RE: DSUP #2002-0029 Samuel Madden Homes; Docket Item #12 (12/14/02)

DEVELOPMENT SPECIAL USE PERMIT #2002-0029
SAMUEL MADDEN HOMES
City Council Docket Item #12, December 14, 2002
Revised 12.13.02, 3:05 PM

Planning Commission Meeting
December 3, 2002

Building Articulation Proposed By Staff

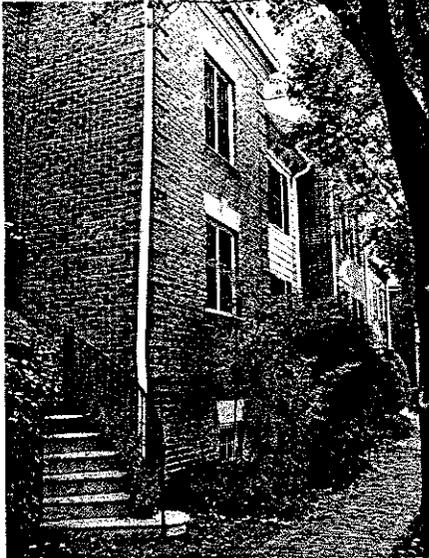
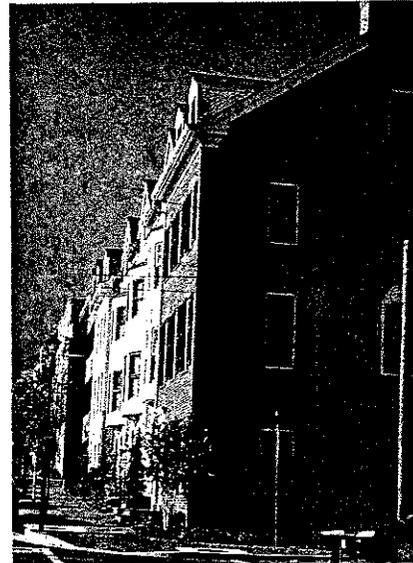
Old Town developed similar to cities, such as Philadelphia, where the townhouses are located close to the street. Historically the townhouses generally were constructed 3-4 units at a time by different builders, resulting in varying front setbacks and inadvertently creating building articulation (2-3 ft. differences between buildings) that creates variety and richness for the street while still maintaining an urban "streetwall." In addition, many of the streets in Old Town are punctuated by variations that provide some articulation and green within the hard-scape (i.e. a unit with a double lot will have a large side-yard, with trees; two or three units will be set back from the street, with small front gardens or porches; the rear yard of a corner unit will face the street that result from units being constructed randomly over time). The proposed buildings lack this building articulation for each block face and, therefore, represent an uninterrupted, monotonous wall of building facades for each block face.

As proposed, the buildings provide little building articulation (18") for only some of the units creating a somewhat relentless streetscape along all the public street frontages. The applicant has stated that they are opposed to providing the building articulation requested by staff. The staff recommending is that the applicant provide additional building articulation of 2-3 ft. for several of the units. This change would enable the buildings to provide additional building articulation while also being consistent with the intent of the Old Town North Urban Design Guidelines to have buildings oriented to the street while also providing building articulation. Additional building variation is necessary to create visual interest along the street and to reduce the perceived mass of the buildings.

5. **CONDITION REVISED BY PLANNING COMMISSION:** Buildings # 5, 6, 13 and 18 shall provide a minimum of three feet building variation (articulation) from the adjoining townhomes adjacent to the public streets frontage frontages. Dimension lines shall be provided on the final site plan to ensure the three foot variations. (P&Z)(PC)

Building Articulation Proposed By Applicant

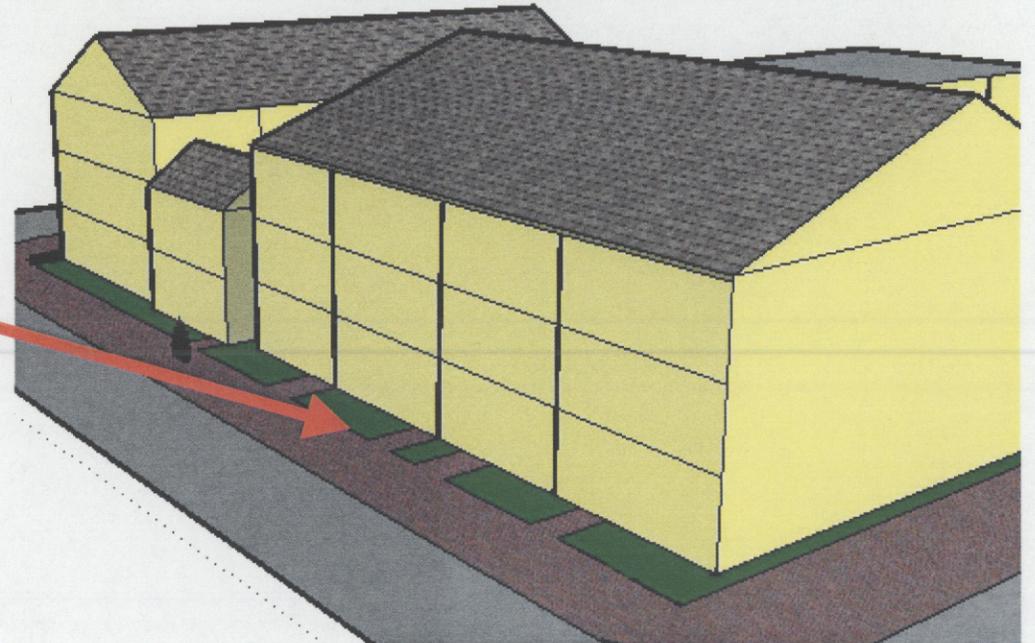
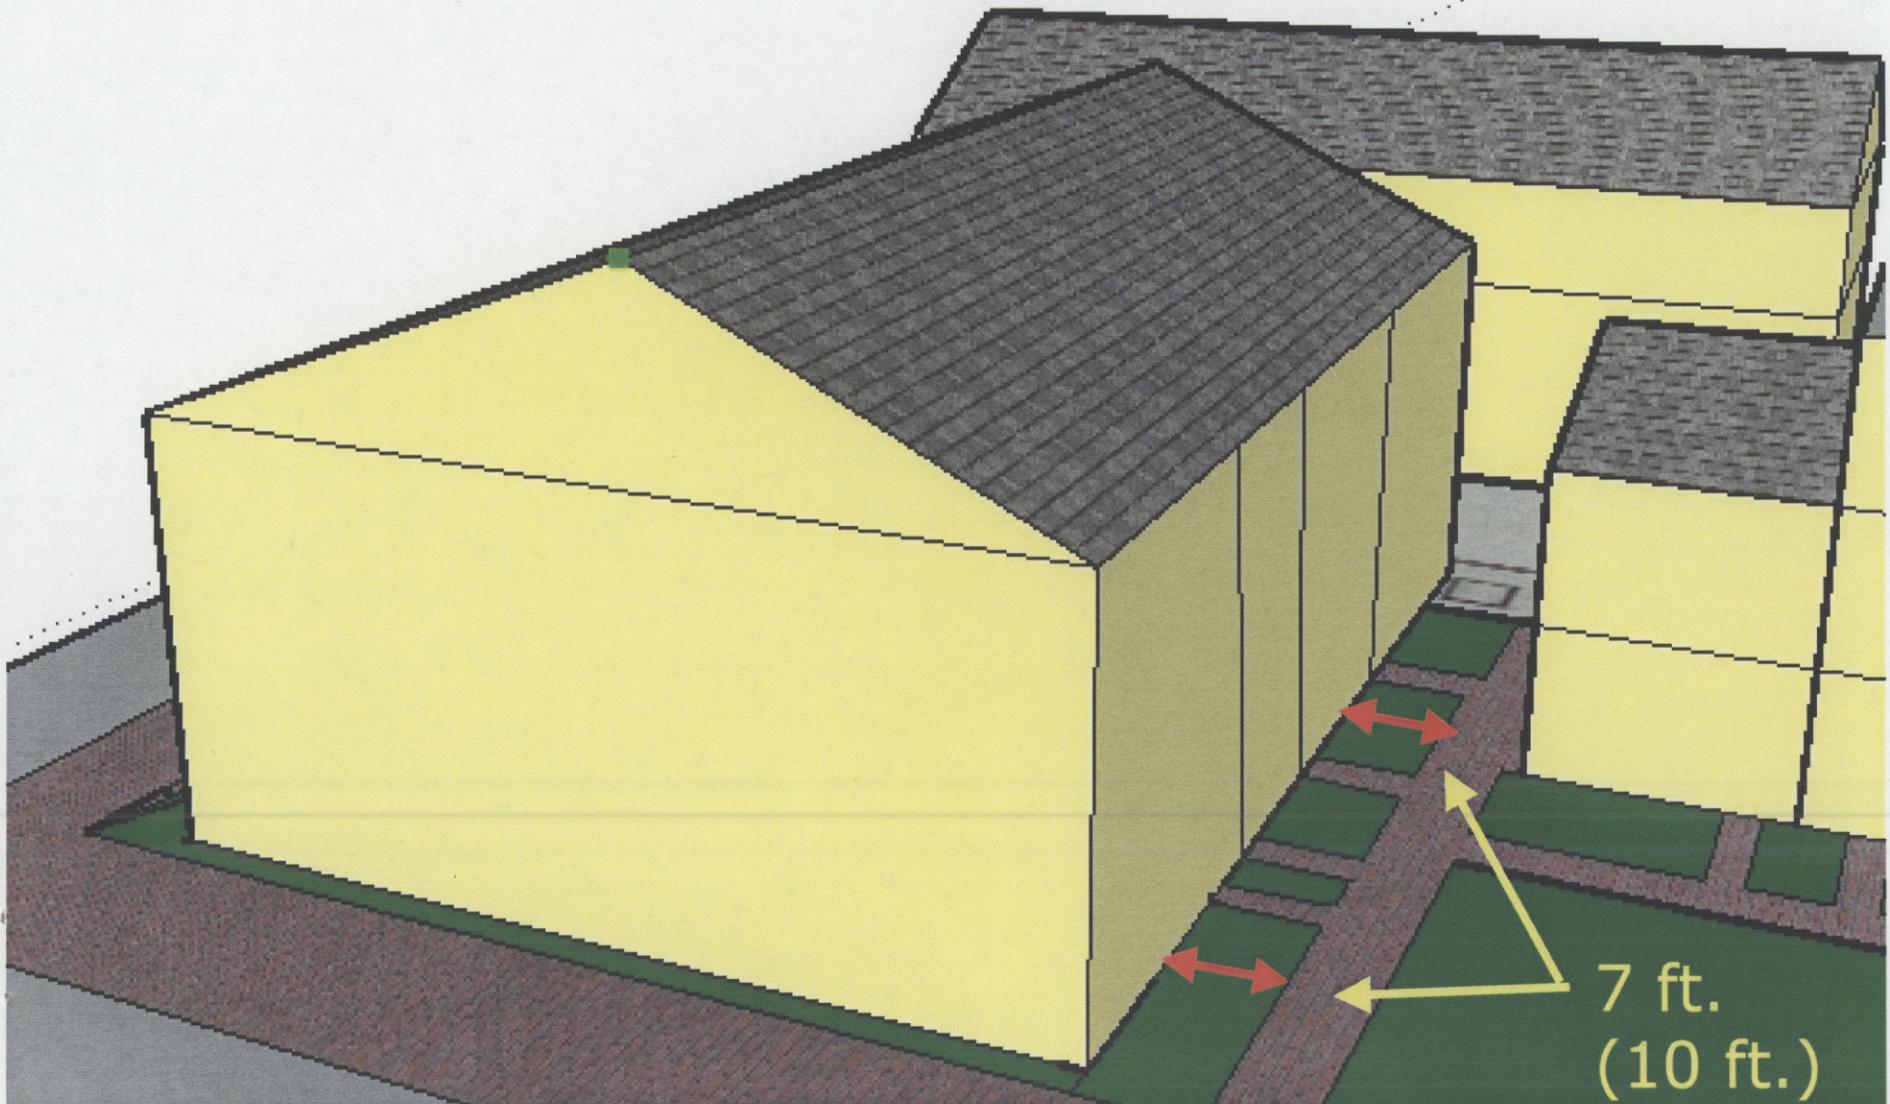
4 ft landscape area and no building variation from the adjoining townhomes

7 ft. landscape area adjacent to the street and 3 ft. building articulation from the adjoining townhomes
